UNITED STATES ENVIRONMENTAL PROTECTION AGENCY
REGION 5
77 WEST JACKSON BOULEVARD
CHICAGO, IL 60604-3590

Re: EPA's response to Tecumseh Products Company's September 30, 2013 Supplemental Submission to the Human Exposure Environmental Indicator Report (MID005049440)

Attachment – Investigation Deficiencies & Required Actions

Figure 1: Interpretation of Potential Plumes

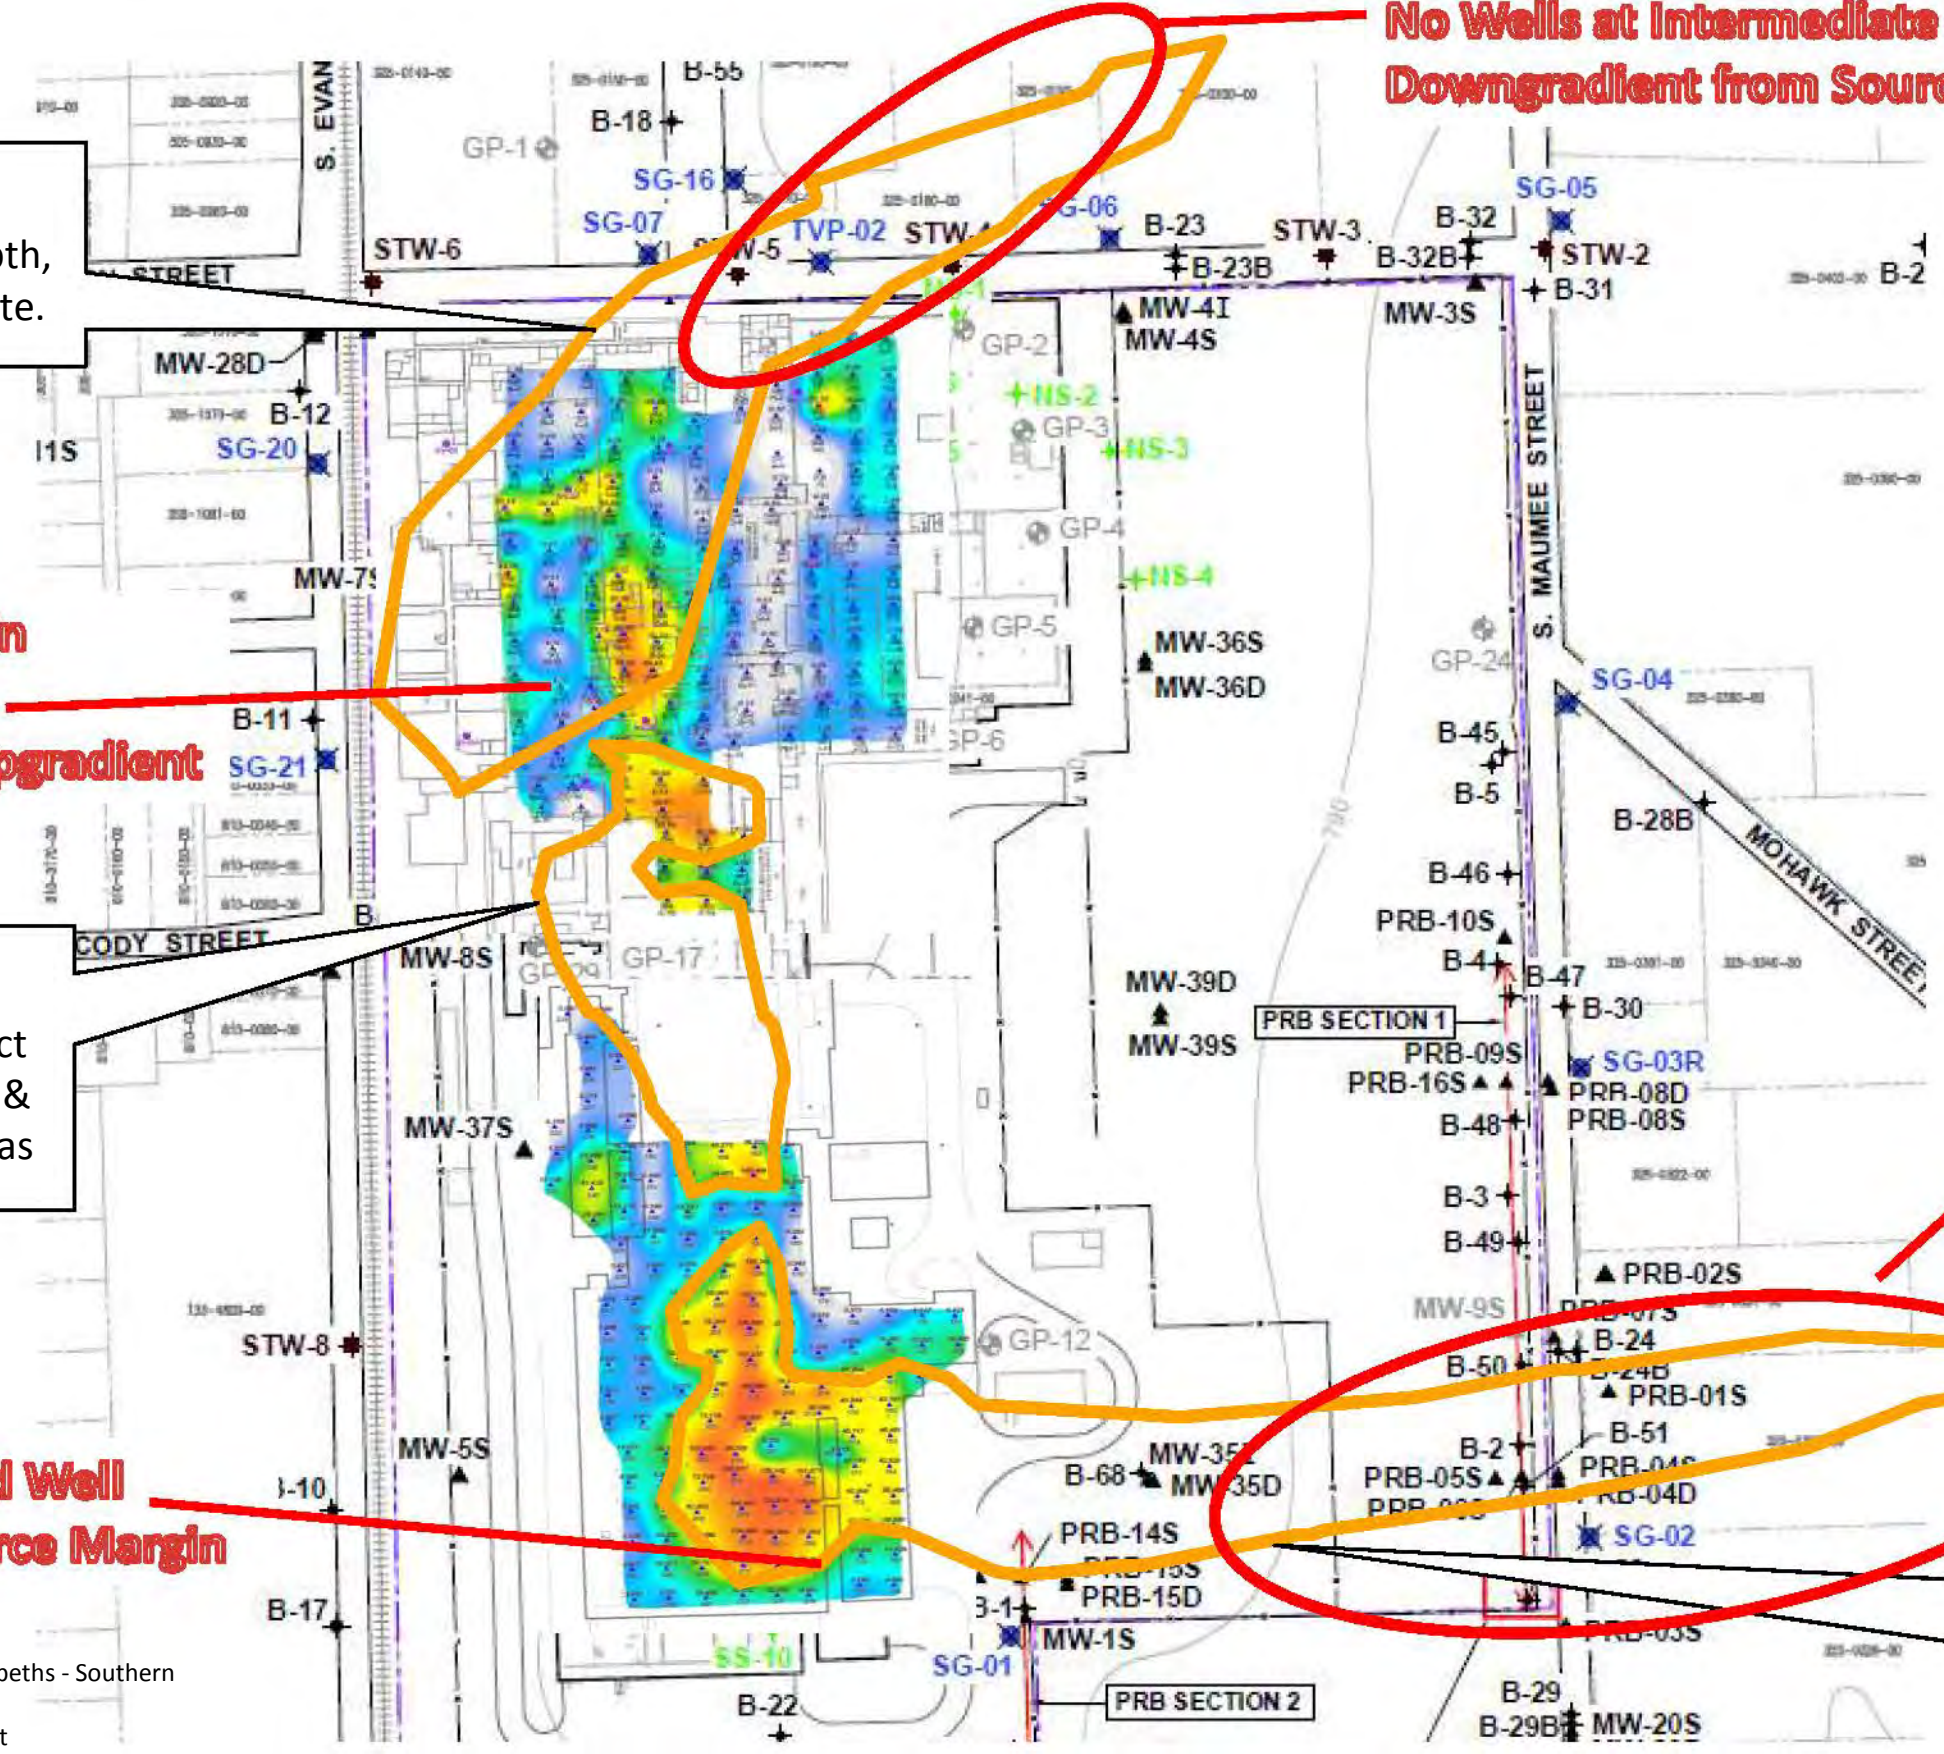
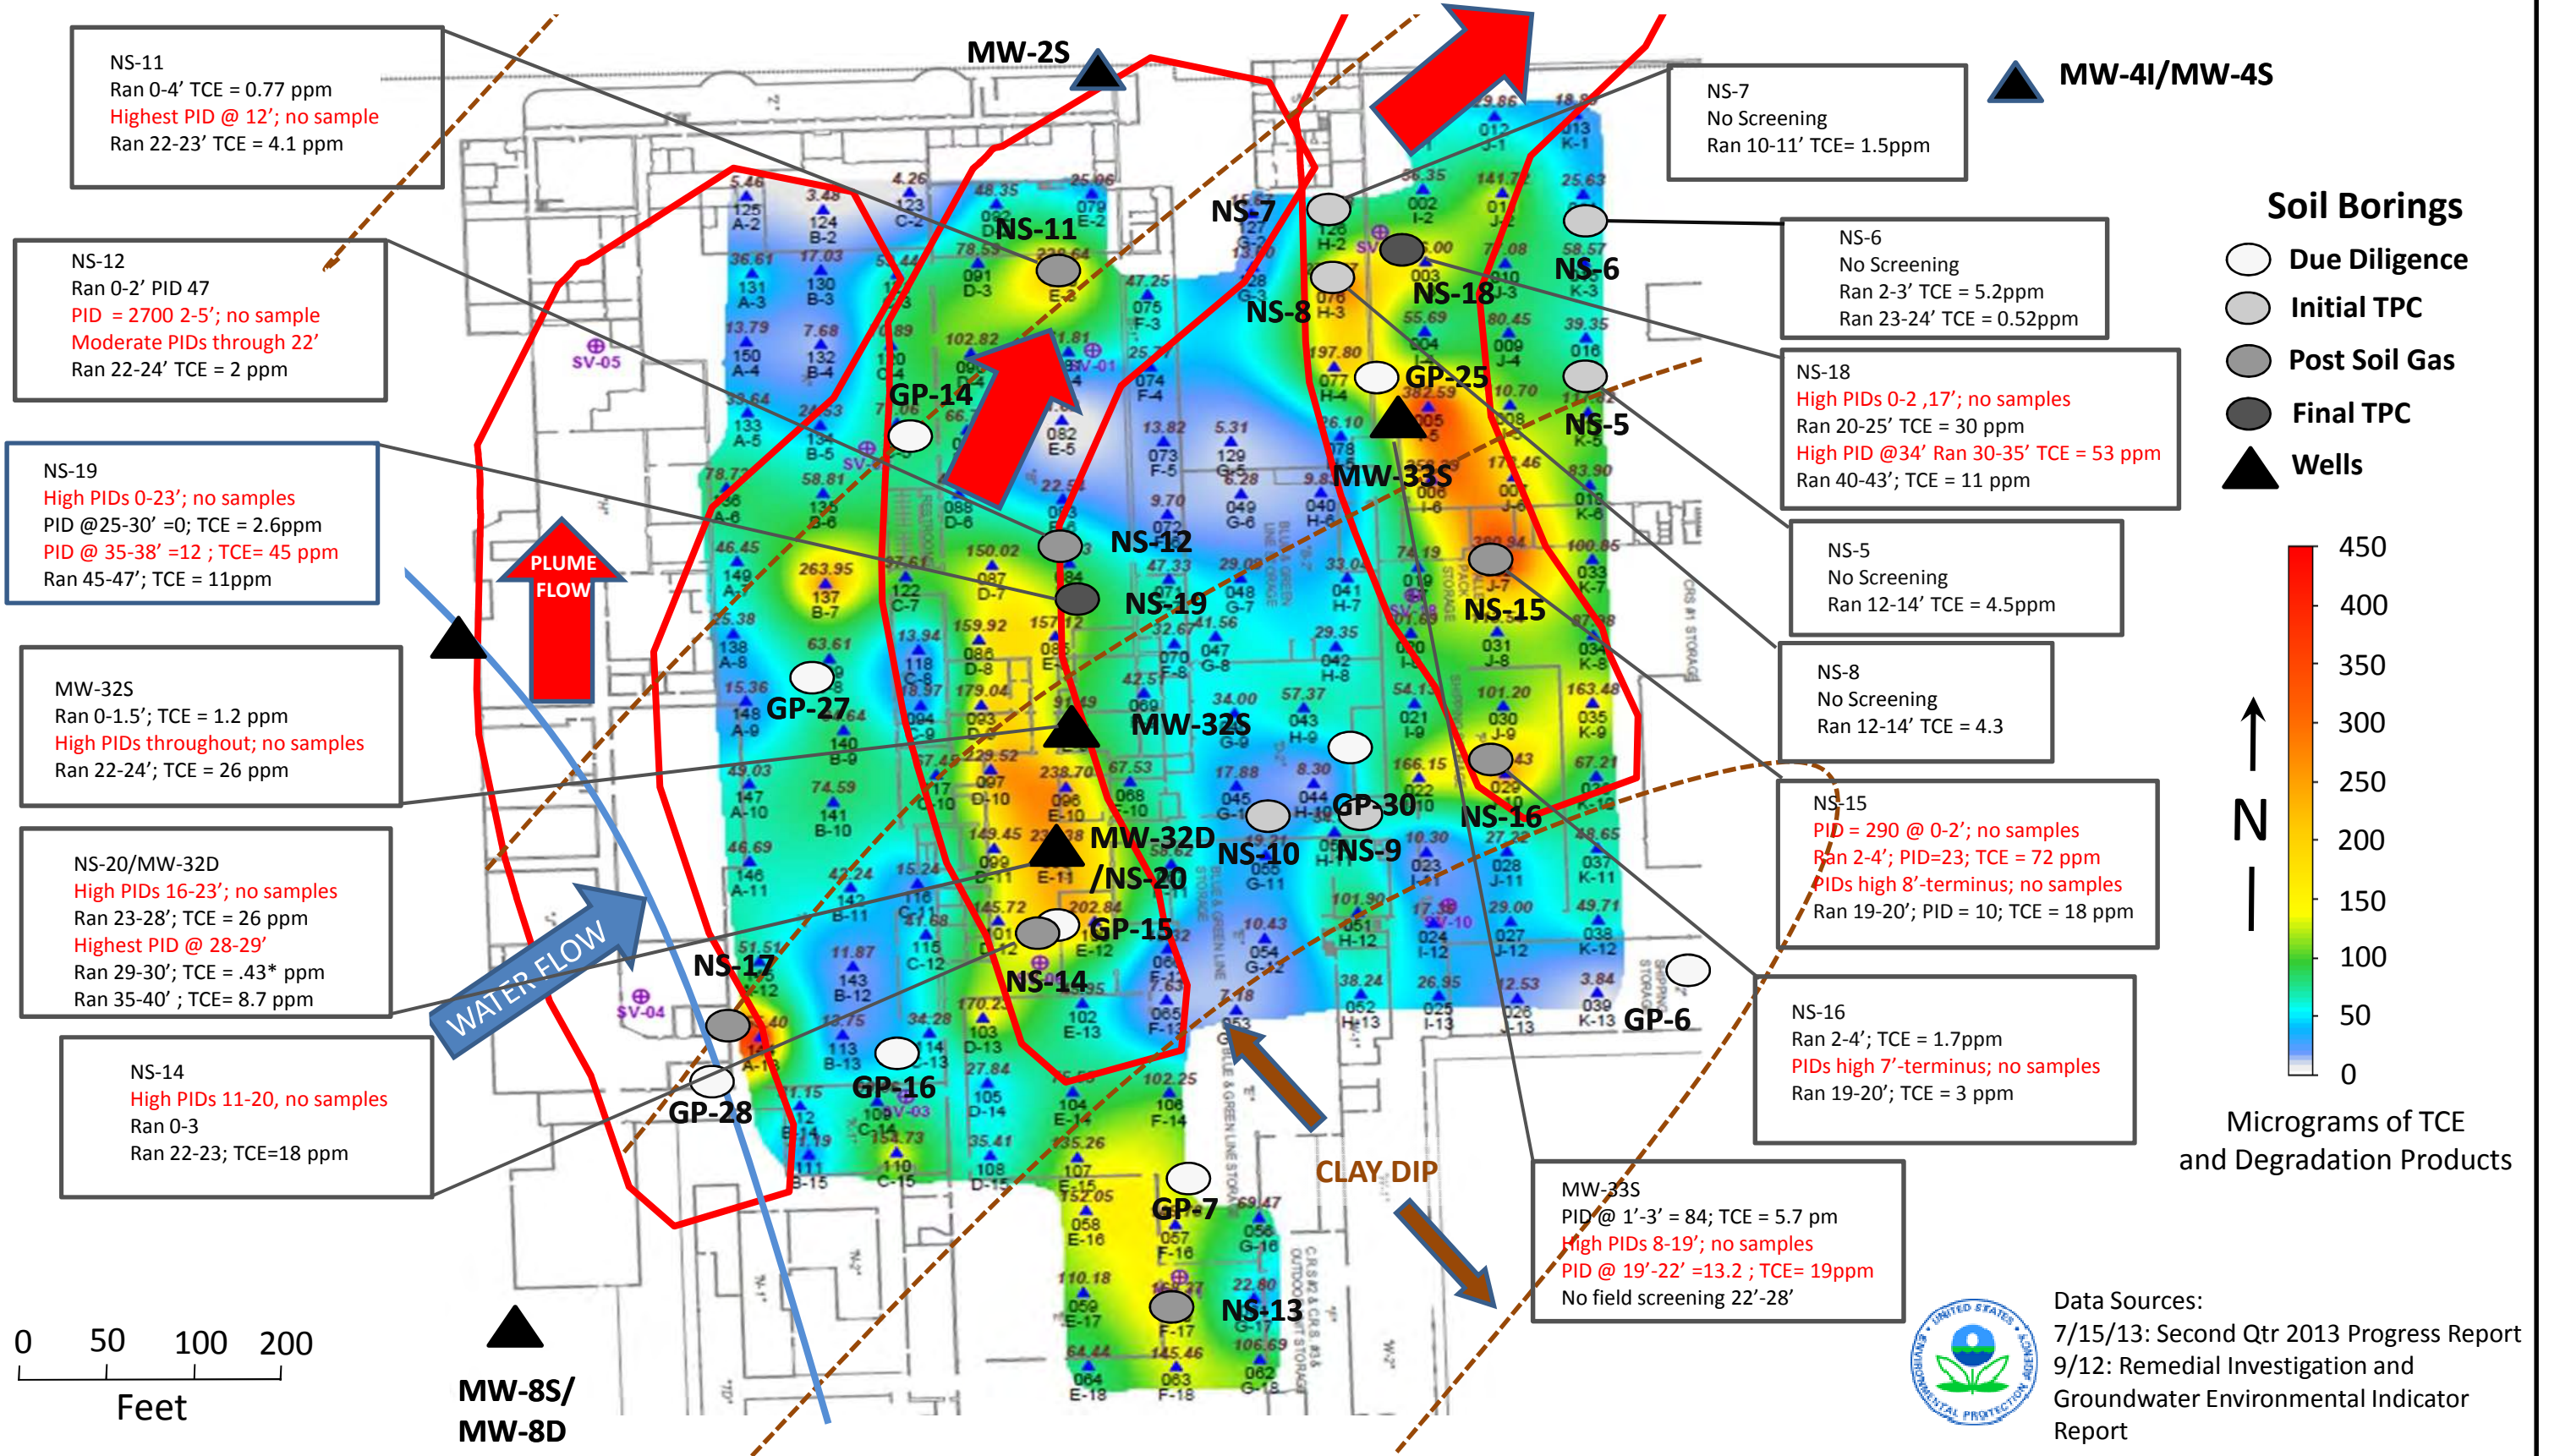
- Many boring locations were installed at distances of 100 feet or more from apparent source areas identified by TPC (*see, Figures 1 & 2*).

- EPA discussed with TPC in October 2012 the apparent migration of contaminants from shallow to deep intervals (greater than 35 feet at NS-18 and NS-19). EPA also highlighted that field screening data and soil sampling results indicate the residual impacts are undefined downgradient and off-site. The three borings (NS-18, NS-19 and NS-20) installed by TPC during the last phase of source area assessment did not adequately address EPA's request to define the lateral and vertical extent of impacts. The majority of the saturated soil zone remains unassessed for those free-phase contaminants that are sinking below the water table, and only the last three borings targeted soils at depth with no further work completed. Contamination extends undefined to beyond B-35 from this area (*see*, **Figure 1**).

- High groundwater impacts were found at NS-2, NS-5, NS-6, NS-11 and NS-14, but the groundwater plume core remains undefined and unassessed because permanent wells are located upgradient or cross-gradient from impacts. There are no wells downgradient from sources, as shown on **Figure 1**.

- Passive soil gas surveys show 1,1,1-TCA at adjacent margins of both surveys that suggest the presence of an unidentified source area in the central building (*see*, **Figure 1**). The area was excluded from passive soil gas sampling. TPC installed only one boring in this 562,500 sq. ft. area, relying on due diligence testing to document site conditions. It is presumed that a due diligence assessment is not intended to characterize or define the extent of impacts. The one boring installed by TPC (NS-13) had high field screening readings throughout the entire soil column that were not analyzed, and heavy solvent impacts in the groundwater that were not defined or monitored. Very high TCE impacts (118,000 parts per billion volume-ppbv) were found in soil gas in this area at SV-11, and the source was not identified.

- High impacts were found in grab groundwater samples at NS-6, NS-18, and NS-20 (among others). No monitoring wells were established downgradient from these locations (*see, Figure 1*). All downgradient wells were installed at great distances from the source(s).
- Heavily impacted wells NS-4S/I appear to be located cross-gradient from the plume path, and at shallower depths than impacts found at NS-18. EPA is concerned that groundwater contamination may be migrating off-site between MW-2S and MW-4S/I from NS-6 at deeper

- TPC reported high impacts in grab groundwater samples at GP-21 and GP-22³ and SS-8⁴; however, no monitoring wells were established downgradient (*see*, **Figure 1**). All wells were positioned near the property line at great distances from the source(s) with the exception of MW-35I, installed after EPA's second request for a well at a proper depth downgradient from the source.

- The wells established by TPC appear to display a selection bias towards low concentrations due to the installation depths (*see, Figure 3*), and because the wells were positioned at great distances from the source areas (*see, Figure 1*).
